ZONING CHANGE REVIEW SHEETCASE: C14-2023-0065DISTRICT: 7ADDRESS: 5506 and 5514 Grover Avenue & 5515 Roosevelt AvenueZONING FROM: MF-4-NP and SF-3-NPTO: MF-6-NPSITE AREA: 2.33 acresPROPERTY OWNER: Brentwood Townhomes, L.P., Laura and Steve Beuerlein, and Biagini, LP.AGENT: DuBois, Bryant & Campbell, L.L.P. (David Hartman)CASE MANAGER: Dana Moses, 512-974-8008, dana.moses@austintexas.govSTAFF RECOMMEDATION:

MEMORANDUM

To: Kelly Rees, P.E, (Kimley-Horn)
CC: Renee Johns, AICP; Ramin Komeili, P.E (Austin Transportation & Public Works)
FROM: Nathan Aubert, P.E.
DATE: October 17, 2023
SUBJECT: 5506, 5514 Roosevelt Ave and 5515 Grover Ave NTA (C14-2023-0065)

Figure 1: Site Location. Figure from plan set submitted in Amanda dated 05/12/23.

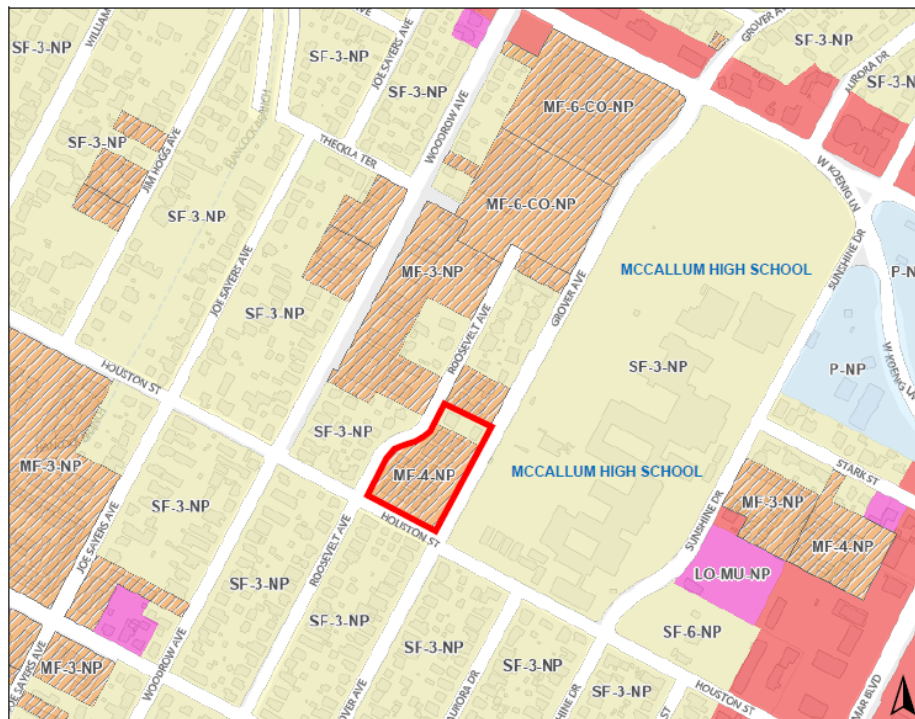
The proposed development includes a 195-unit multifamily complex, comprising both three-story buildings and four-story buildings. It is a 2.33-acre tract on the NW corner of Grover Avenue between Roosevelt Avenue and Grover Avenue north of Houston Street, see Figure 1 below. The only proposed access is onto Grover Avenue, a level 1 street. The proposed, adjusted trip generation exceeds the 300-trip threshold for a local street specified in 25-6-114 of the LDC. The Transportation Development Services (TDS) division has conducted a Neighborhood Traffic Analysis (NTA) and offers the following comments.

The project proposes access onto Grover Avenue only, identified as a level 1 residential collector/local street in the ASMP, and no access to Houston Street, and Roosevelt Avenue. The right-of-way along Grover Avenue has an average of 64 feet and a minimum of 55 feet. There is approximately 36 feet of pavement width, two striped travel lanes, curb, gutter, sidewalk on the east side of the street only, and no bicycle facilities. The desired right-of-way along Grover Avenue is 58-64 feet according to ASMP.

1. Grover Avenue currently has sidewalk gaps along its length. At the time of site plan this development will be required to build sidewalks, with associated curb ramps, along their frontage, as well as fill in any gaps on the west side of Grover Avenue from West Koenig Lane to Houston Street.
2. If the number of units proposed in Table 1 is exceeded, the TDS division may reassess the NTA.
3. Street Impact Fee (SIF) Ordinances 20201220-061 and 20201210-062 have been adopted by City Council and are effective as of December 21, 2020. The City has started collecting street
